CITY PLANNING COMMISSION

APPLICATION: A. Negative Declaration
B. Special Permit to allow an office building

LOCATION: NEC Gateway Oaks Drive and Venture Oaks Way

APPLC. NO. P86-127 **MEETING DATE** May 8, 1986 **ITEM NO** 9

SITE DEVELOPMENT PLAN

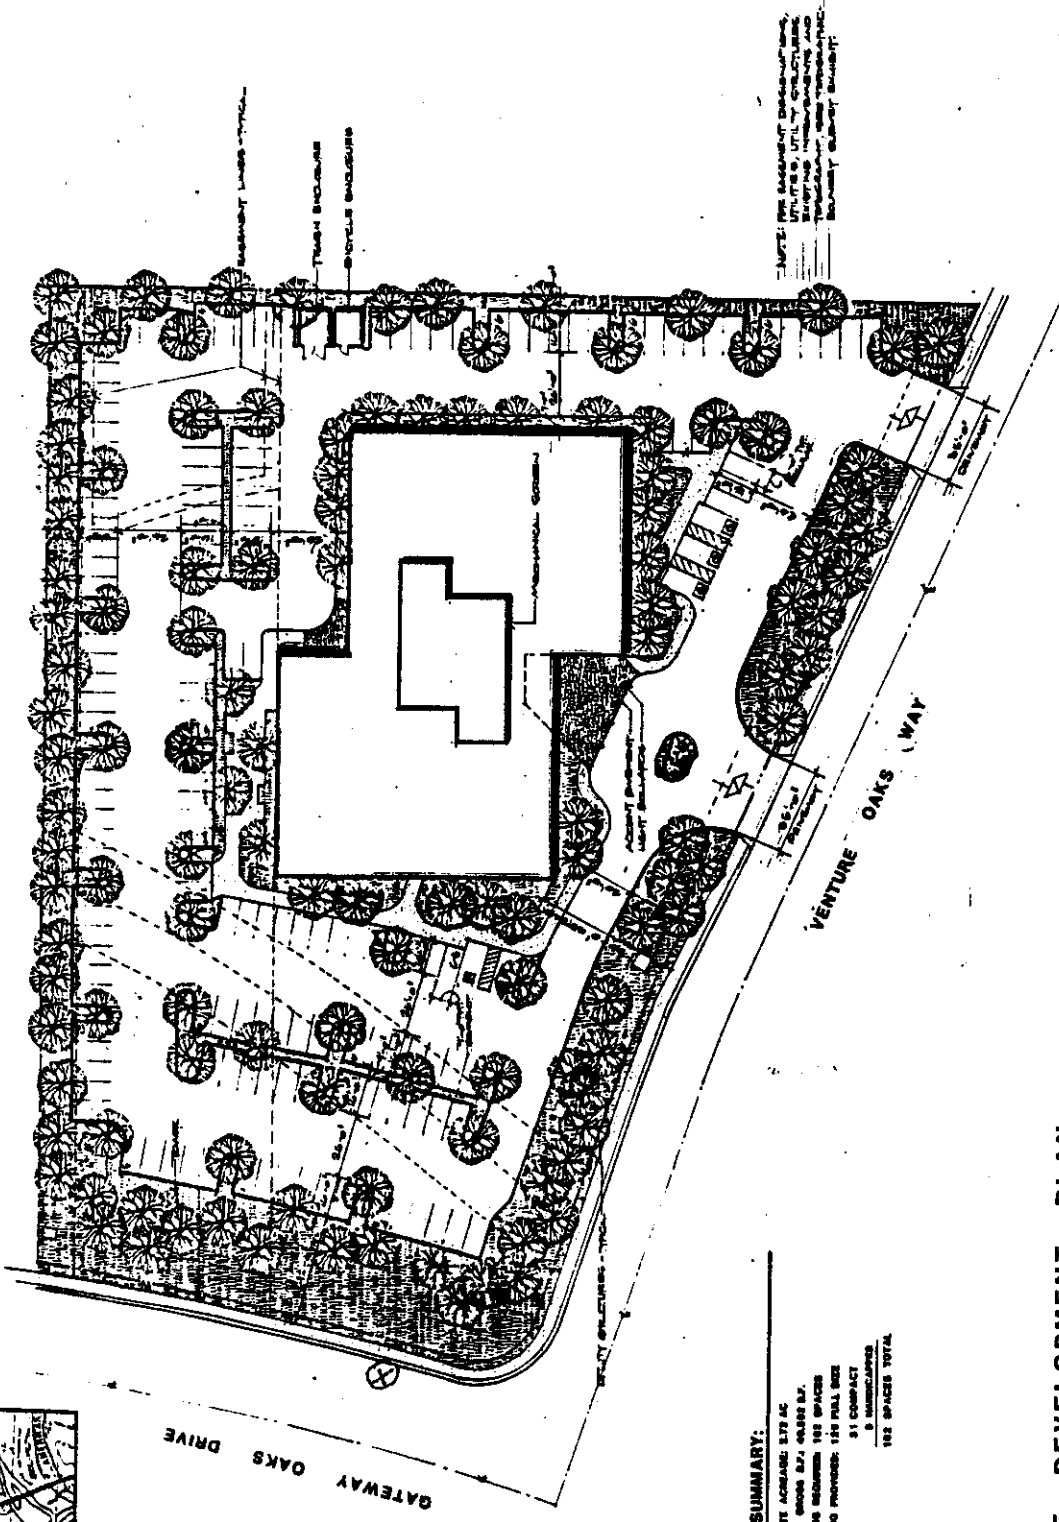
The Gateway Centre PUD also designates the northeast corner of Gateway Oaks and Venture Oaks for an RT bus stop with turnout. The applicant will need to revise the proposed site plan accordingly.

Island in driveway at front of building is unacceptable. Provide better truck access.

1. A revised final site plan shall be submitted to the Planning Director for review and approval prior to issuance of building permits which incorporate the following changes:
 - a. RT bus stop with turnout on the northeast corner of Gateway Oaks and Venture Oaks Drive:

⊗ bus stop w/turnout.

SOUTH ELEVATION
 1/8"-1'-0"

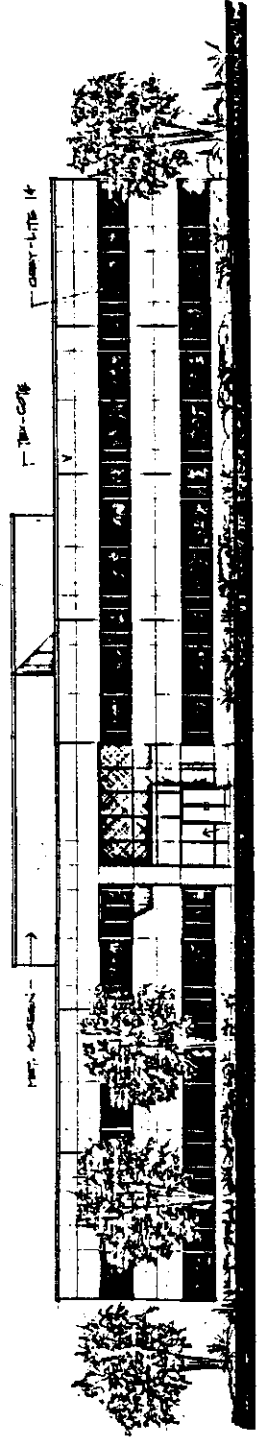
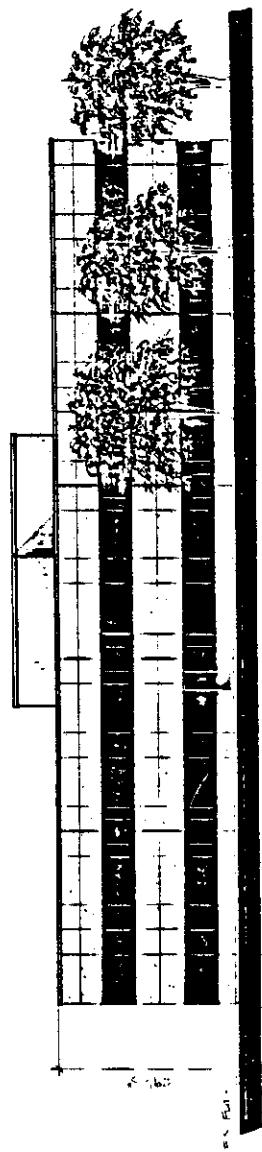
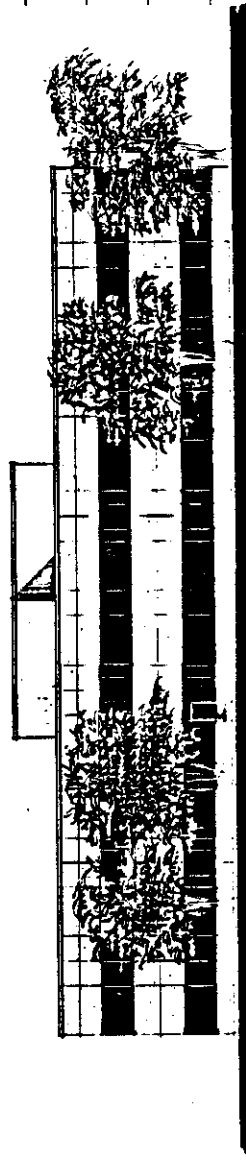
- D. Building Design: The proposed structure consists of a two-story building (plus mechanical penthouse) to be constructed with a Tex Kote exterior finish and reflective glass. The entryway of the building will be accented with paving stones and bollards. Staff was concerned with the proposed design of the building. Prior to and after the submission of the application City staff and the property owner and project architect met to review the project design. A compromise was reached on a design which keeps the same footprint and mass with some additional architectural detailing added. Revised elevations will be provided a public hearing by applicant.

- b. Sixteen bicycle storage lockers (8 Class I and 8 Class II and III).
2. The building elevation plans shall be submitted to staff for review and approval prior to issuance of building permits.

PRELIMINARY SHADE STUDY

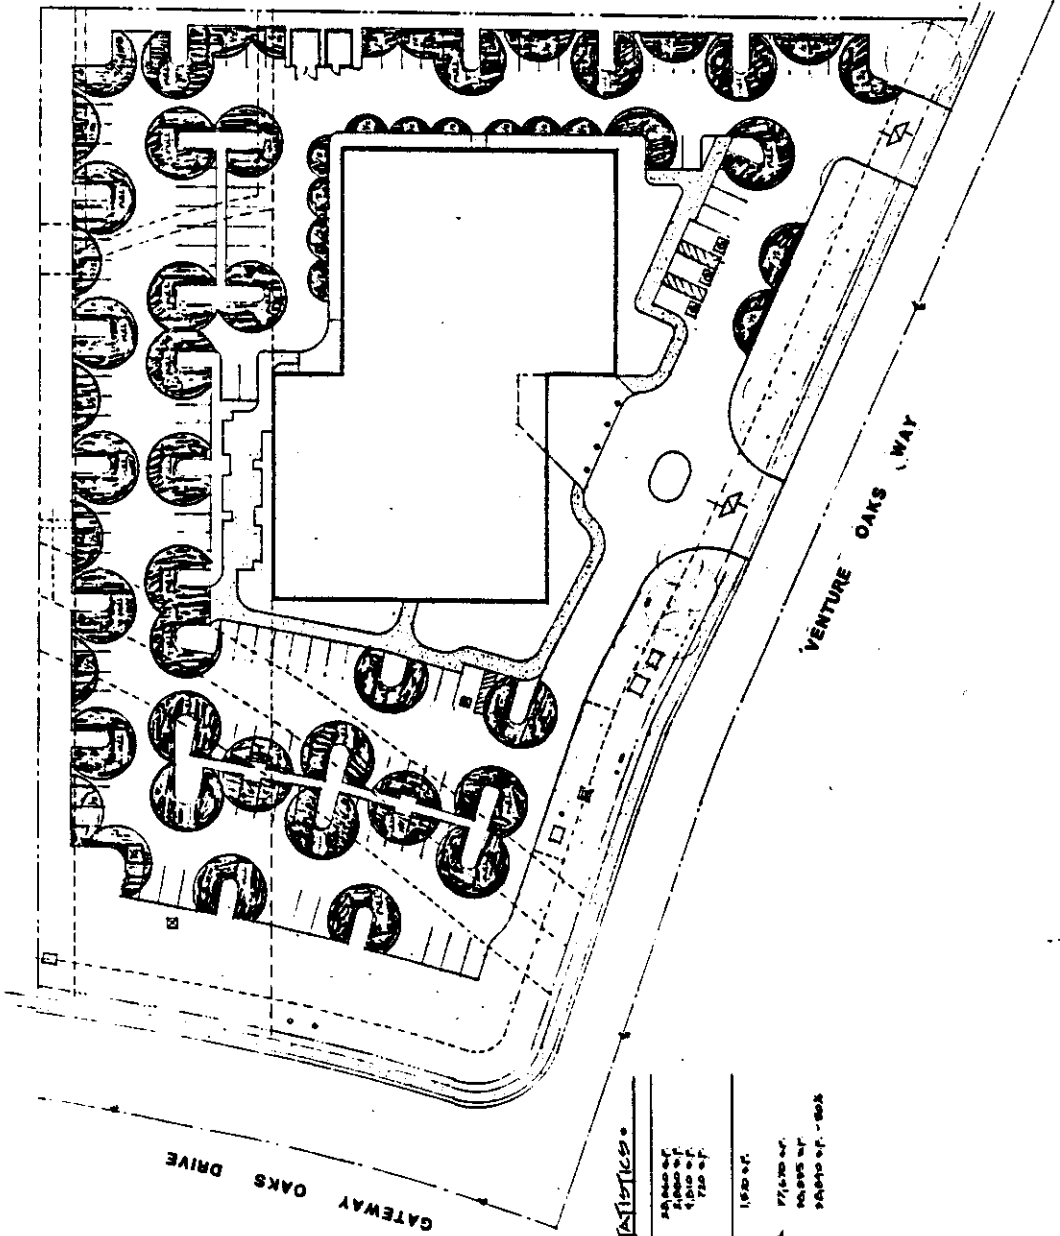
All landscape setback areas shall be bermed (minimum four-feet high) and all berms shall be landscaped with predominantly evergreen trees, shrubs and ground cover. In addition, the parking lot must be planted with trees so that at least 50% of the parking lot will be shaded.
